Adjust parking calculation to reflect as-built conditions.

Re: Project PR-2018-001271 – Proposed Minor Amendment

The purpose of this letter is to explain our request for a minor amendment to the approved Site Development Plan for the Markana Apartments (Phase 1) located at 6301 Alameda Blvd NE. The purpose of the amendment is to adjust the parking calculations based on as-built conditions made necessary due to Fire Marshal requirements and an error in the original calculation. The subject property is legally described as Tract 1, Legacy Apartments and zoned R-MH.

As Built - Parking Count Revised August / 19/ 2020

A1.10
 SITE PLAN

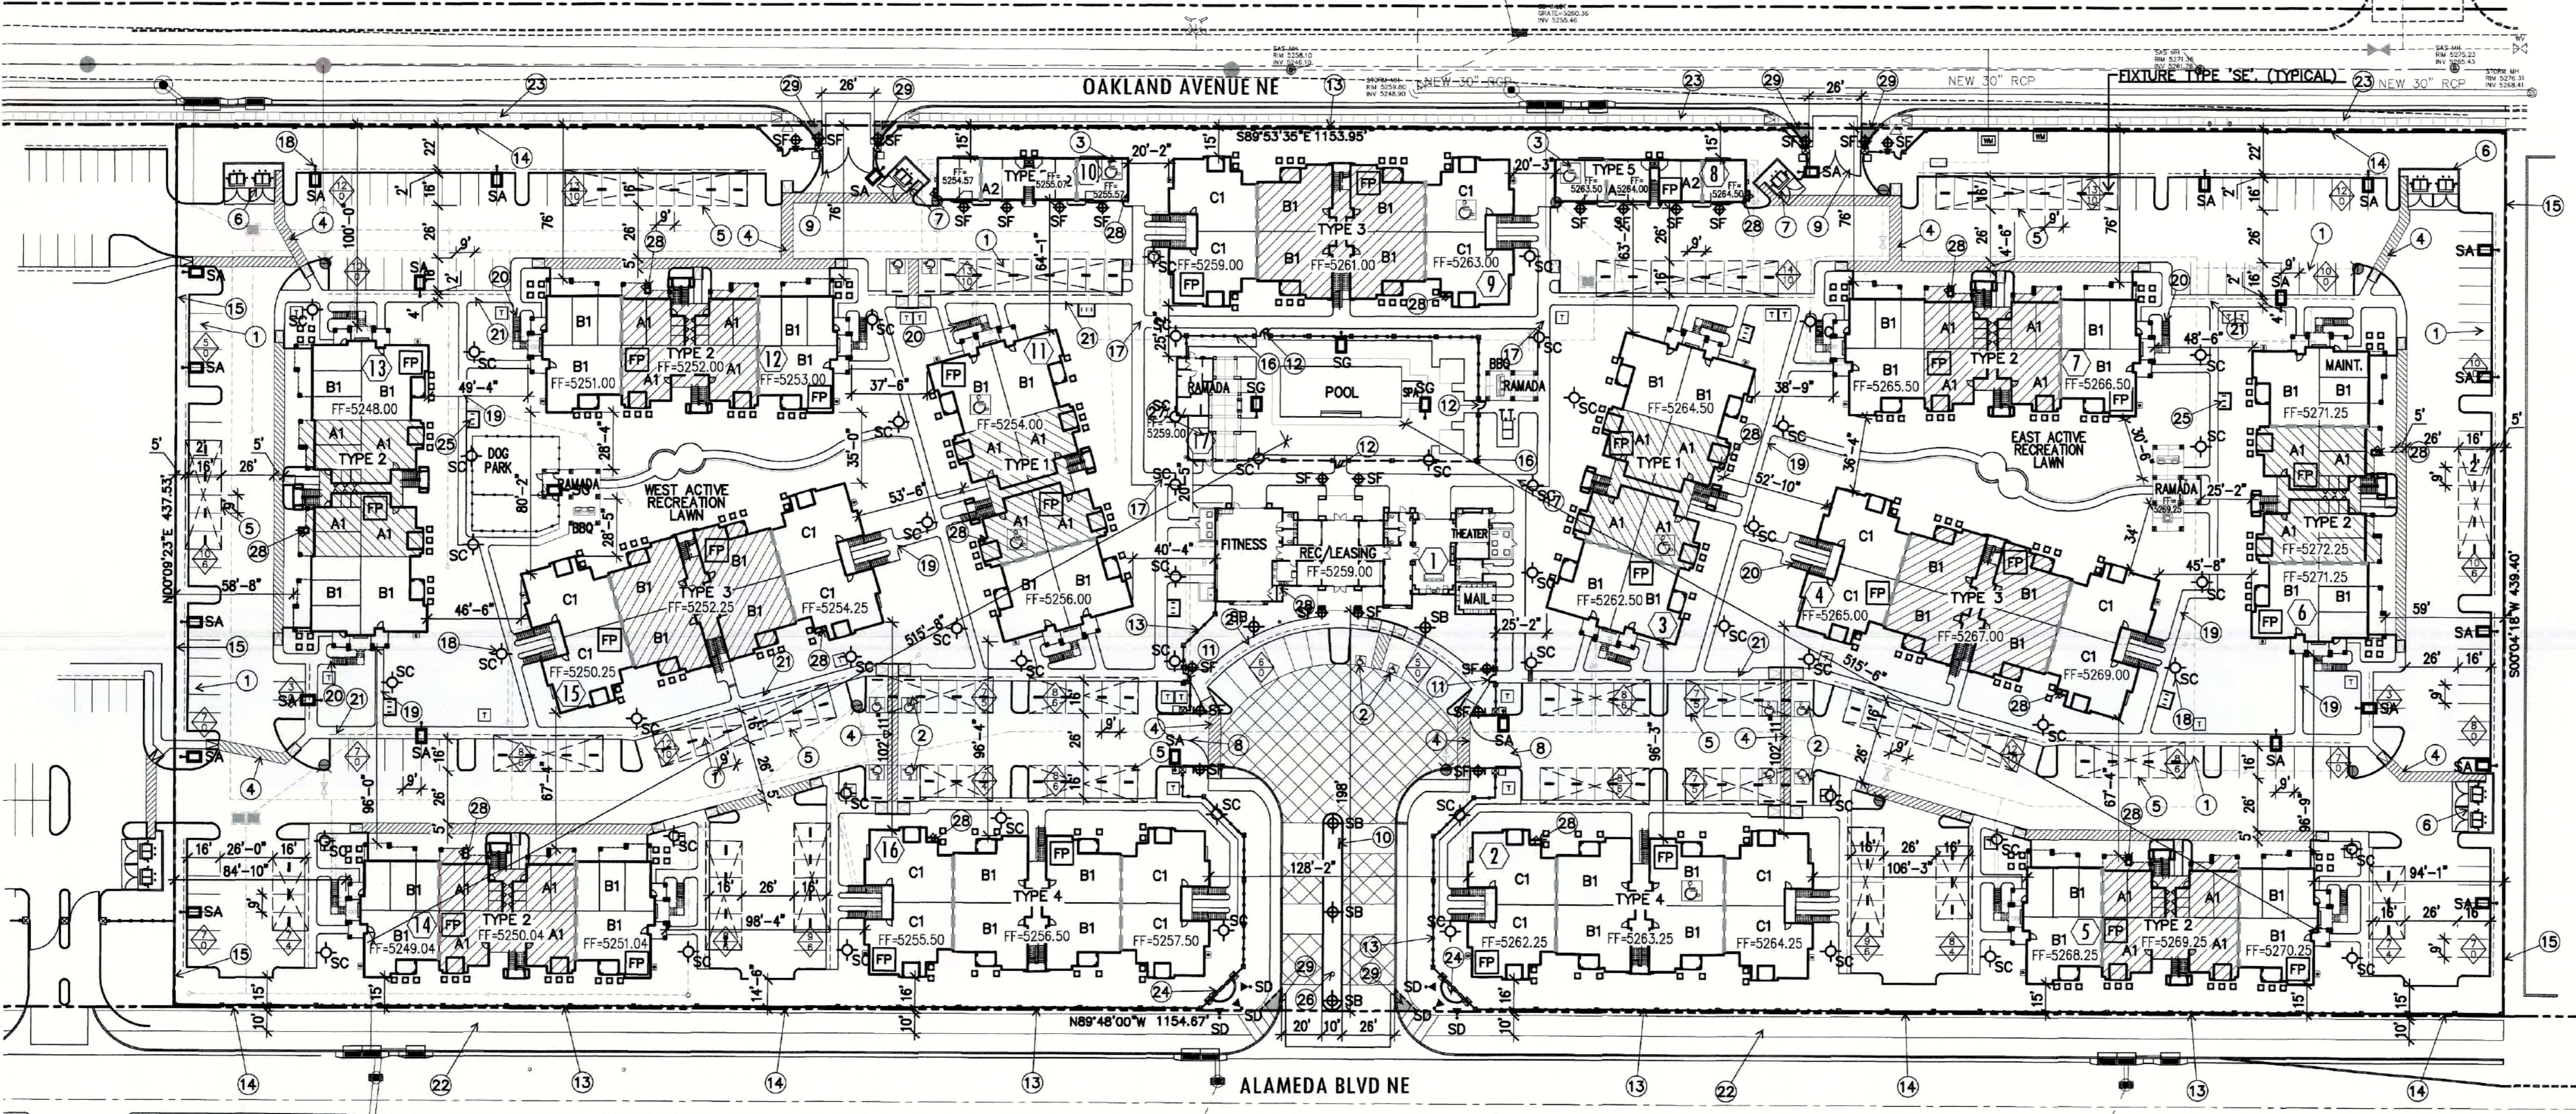
The Site Development Plan was amended by the DRB on February 28, 2018 to remove six parking spaces and make other modifications to allow vehicular access to Phase 2 of the development located on the property to the west (also owned by the applicant). While the total parking was reduced to 415 spaces (5 short of the requirement), a parking agreement was created and filed between the two phases of development and the Phase 2 Site Plan included six parking spaces specifically identified for Phase 1 use in its minimum parking calculations. The Phase 2 Site Plan was approved by the DRB on March 14, 2018 and amended by the DRB on July 18, 2018.

A1.10

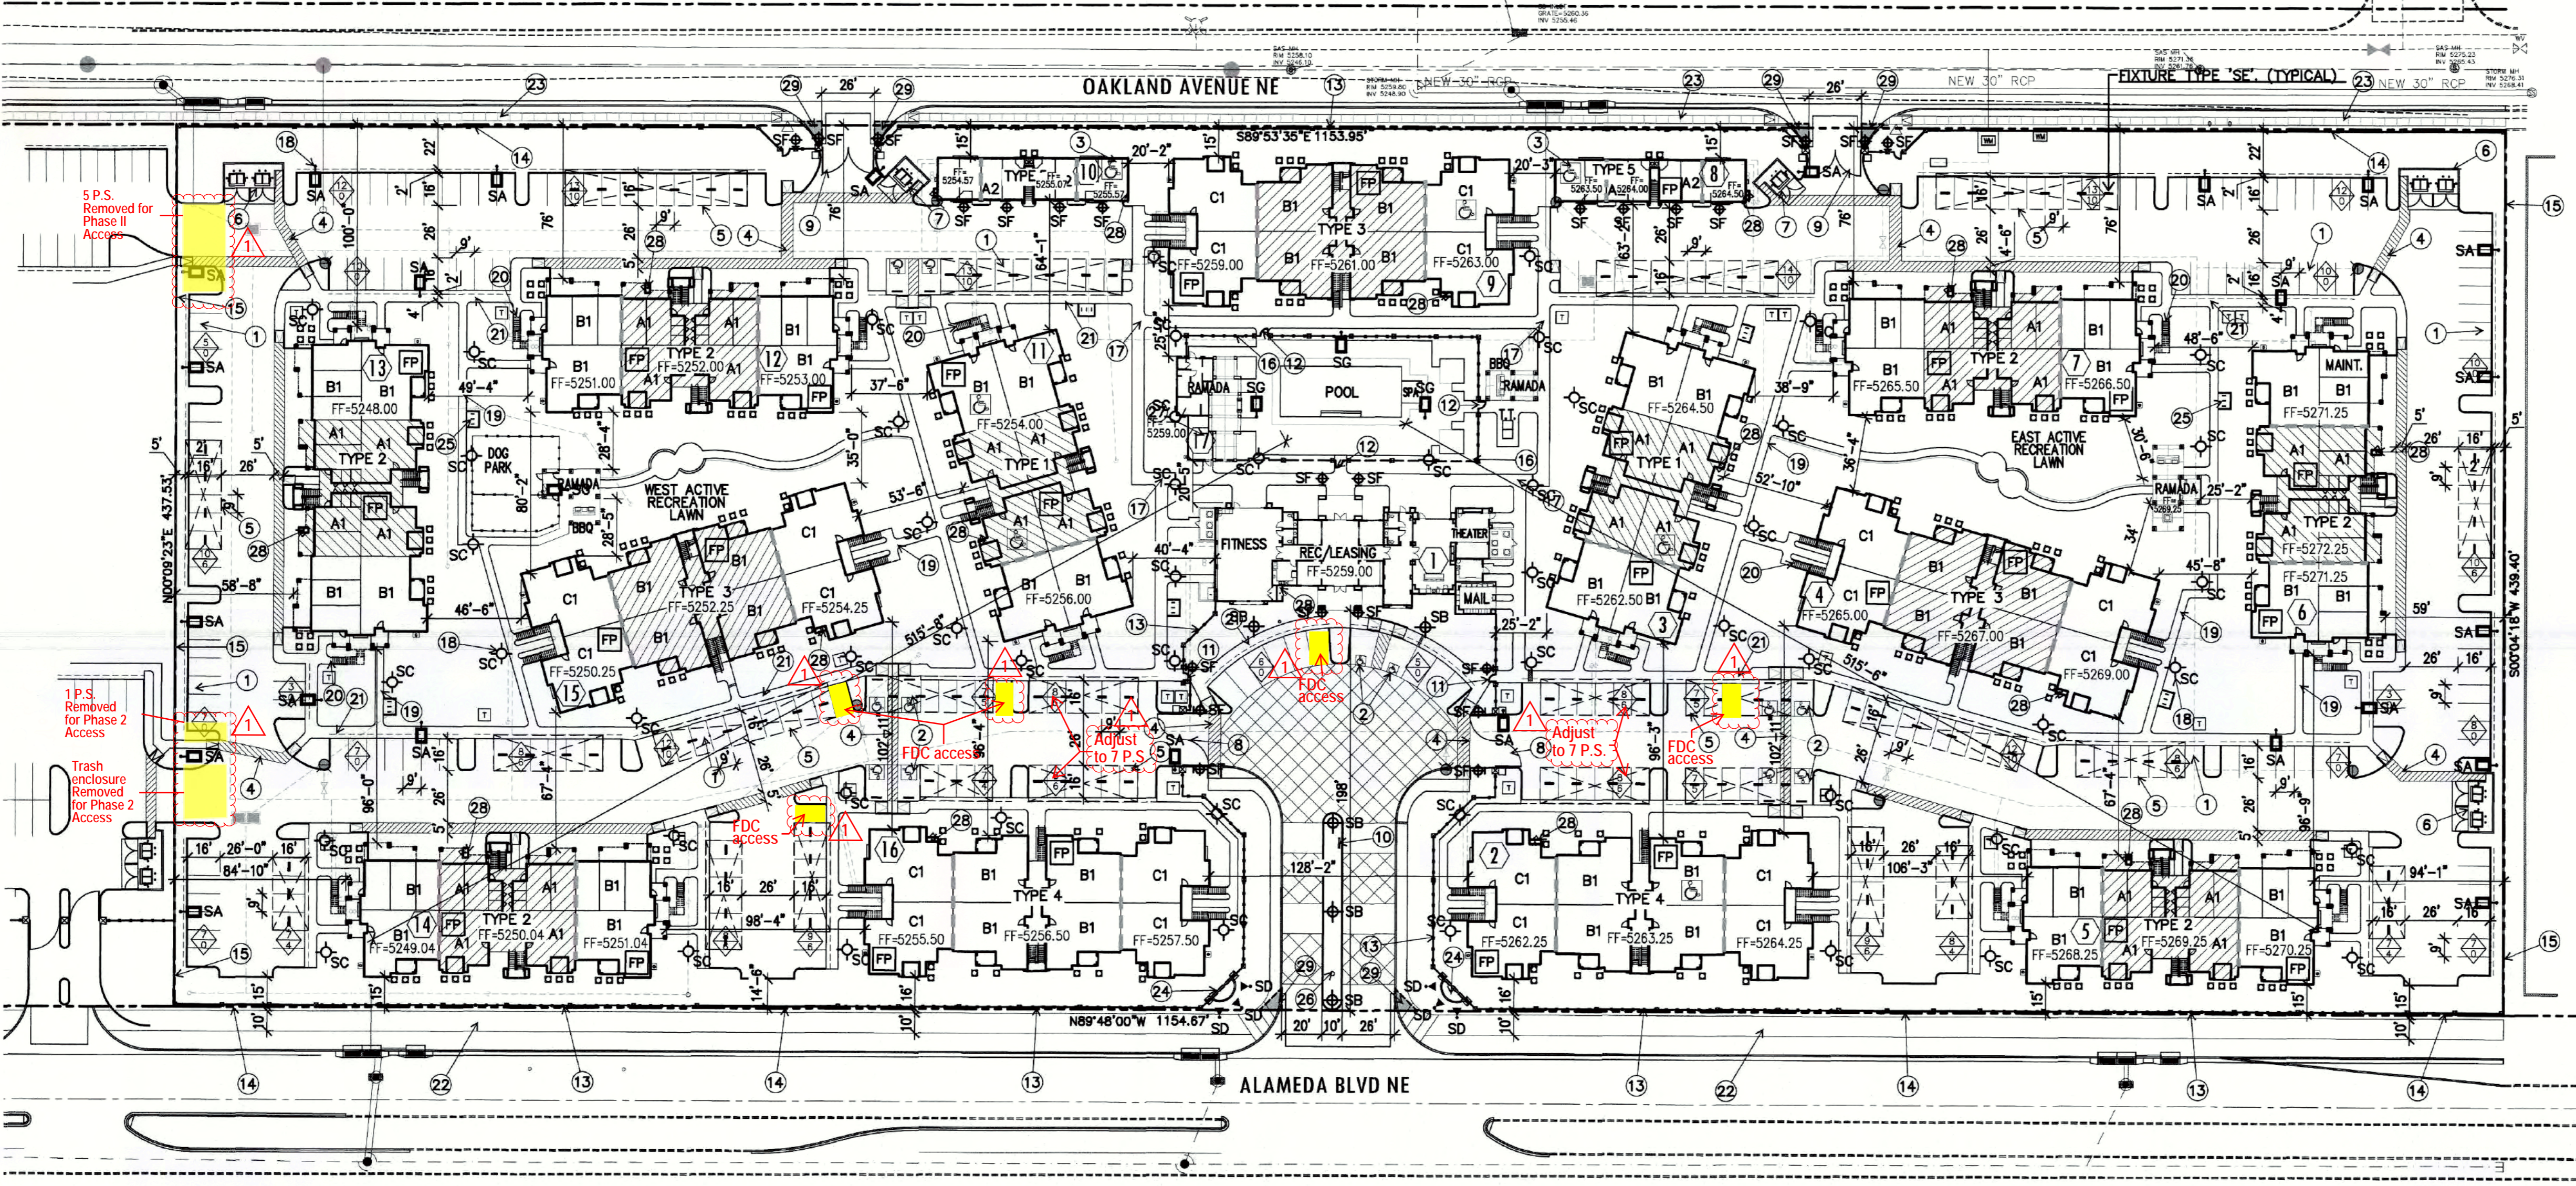
This current Minor Amendment is to update the parking calculations for Phase 1 as follows:

- Reduction of 4 spaces due to a miscalculation on the original plans that should have been noted in the prior approvals.
- Reduction of 5 spaces due to Fire Marshal requirements for Fire Department Connection access.

PARKING SPACE REQUIREMENTS	PARKING RATIO REQUIRED	PARKING SPACES	
			UNIT A1, A2 < 1,000 SF
UNIT B1 > 1,000 SF	104 - 2 BR / 2 BATH	2 / 2	208
UNIT C1 > 1,000 SF	40 - 3 BR / 2 BATH	2 / 2	80
Total Parking Spaces Required			420
OPEN PARKING PROVIDED		185	175
CARPORIT PARKING PROVIDED		187	156
GARAGE PARKING PROVIDED		75	
Total Parking Provided		447	406
